Application for Licence

Licence Number	L9453/2024/1
Applicant	Ulysses Mining Pty Ltd
ACN	153 592 208
File number	DER2024/000427
Premises	<p>Ulysses Gold Project</p> <p>Part of tenements G40/4, G40/5, G40/6, L40/11, L40/12, L40/30, L40/34, M40/3, M40/101, M40/107, M40/110, M40/137, M40/166, M40/174, M40/20, M40/288, M40/289, M40/290, M40/291, M40/292, M40/293, M40/340</p> <p>Shire of Menzies</p> <p>As defined by the premises maps attached to the issued licence</p>
Date of report	13 December 2024
Decision	Licence granted

Figure 1: Map of the boundary and infrastructure layout of the prescribed premises

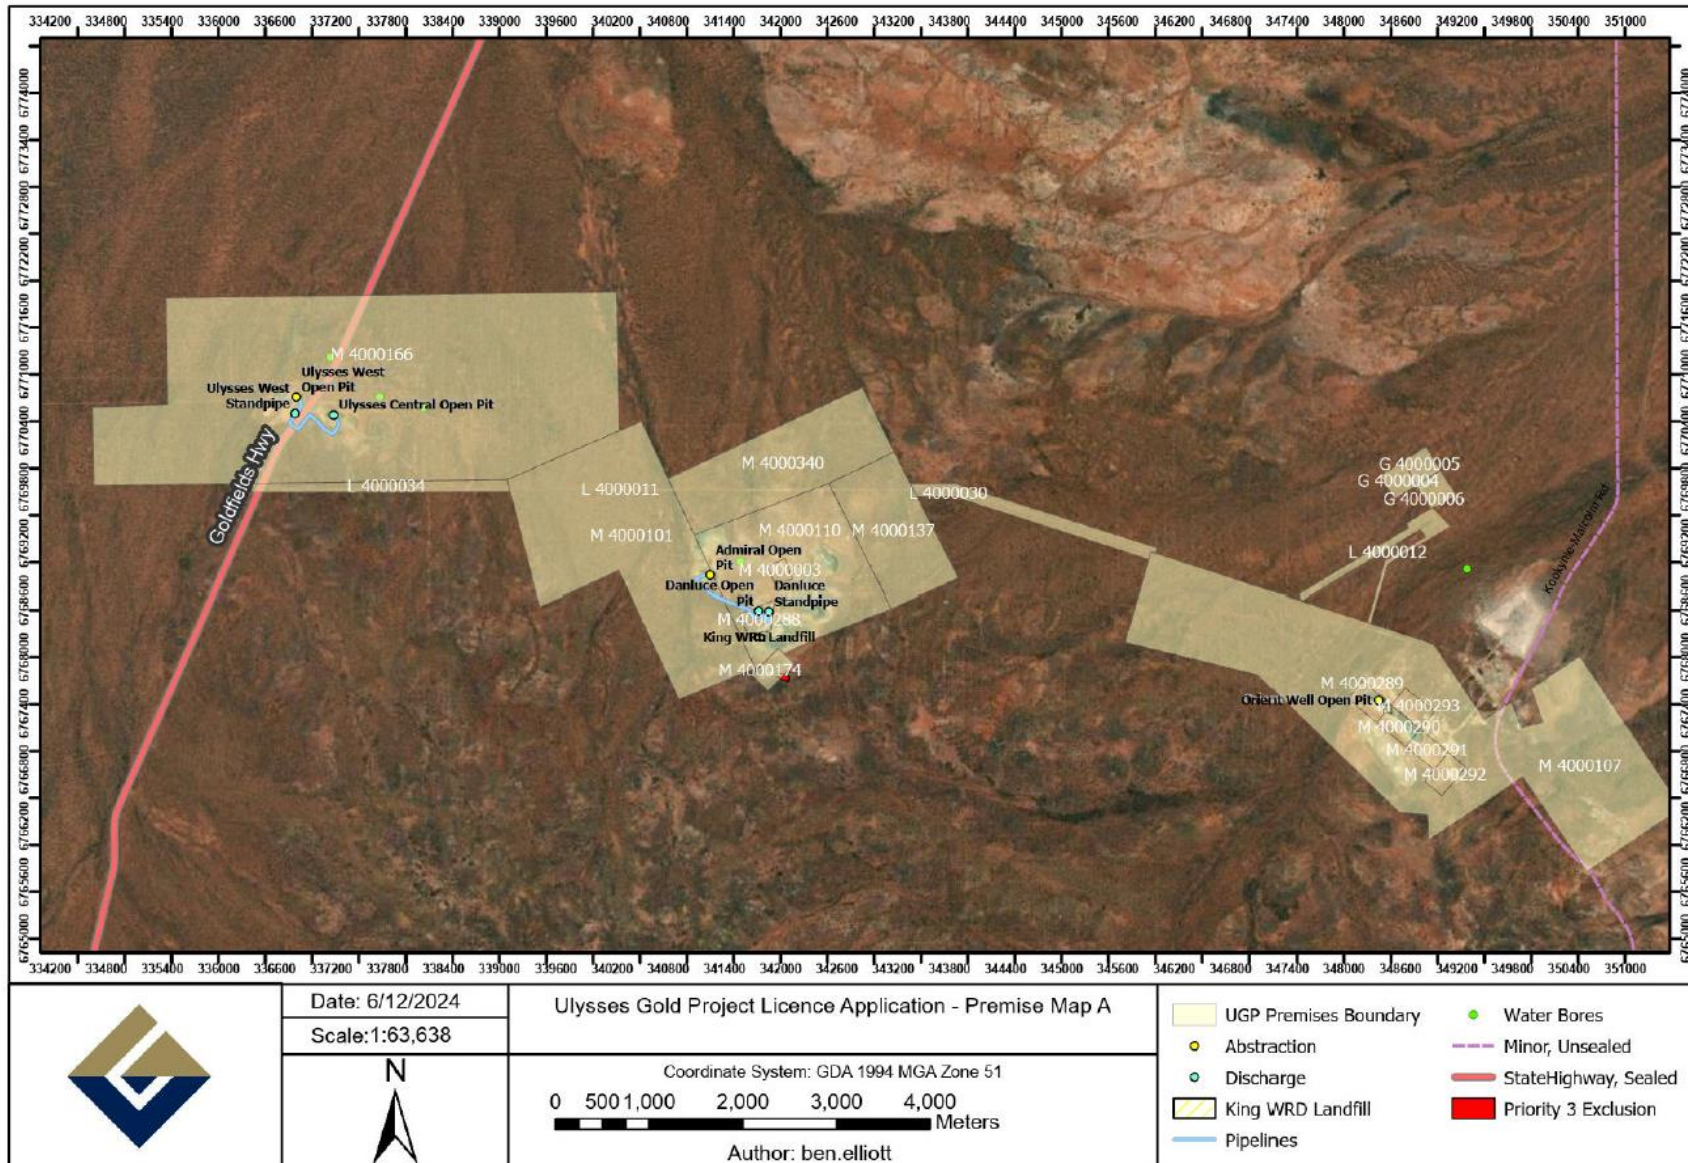
Condition	Summary of applicant's comment	Department's response
Decision Report		
Item 1 - Applicant to provide higher resolution image of the map boundary and infrastructure layout.	Maps updated and attached.	Updated map added to Figure 1.

Figure 2: Distance to sensitive receptors near King WRL

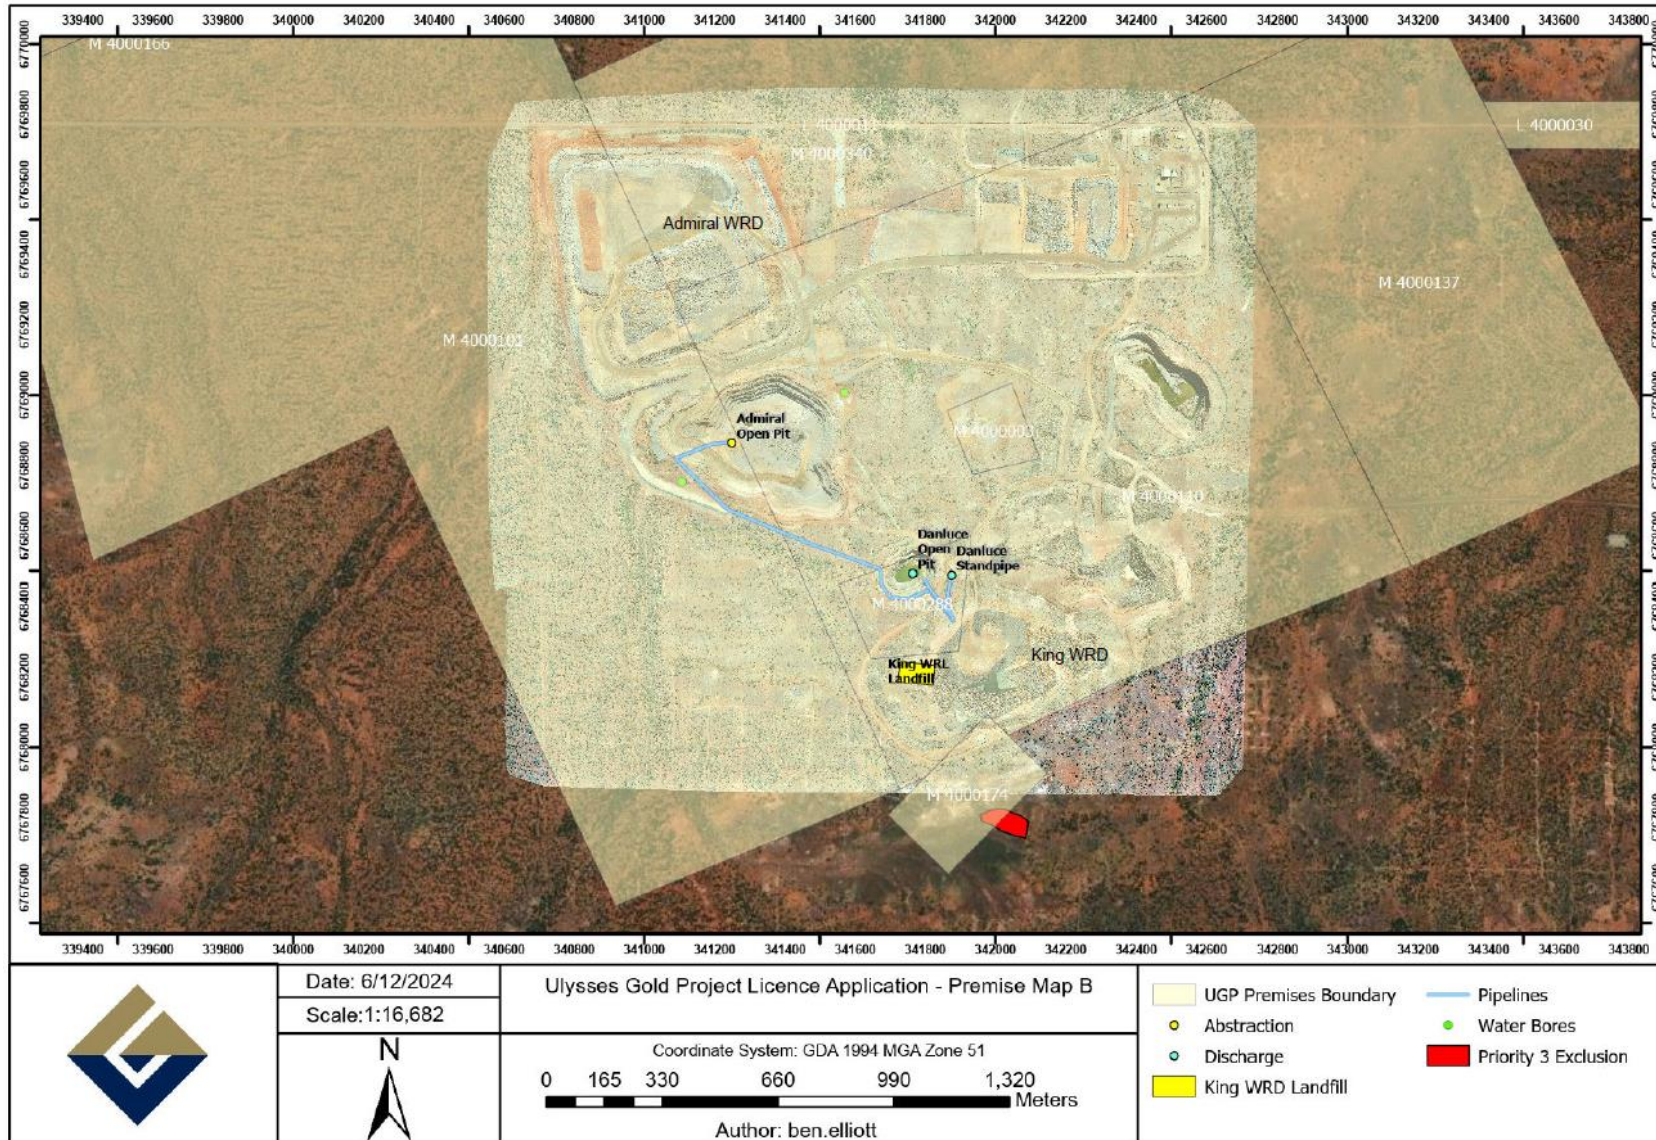
Item 2 - Applicant to depict all sensitive receptors in map where possible.	P3 population of <i>Calytrix hislopii</i> exclusion added to map.	Updated map added to Figure 2.
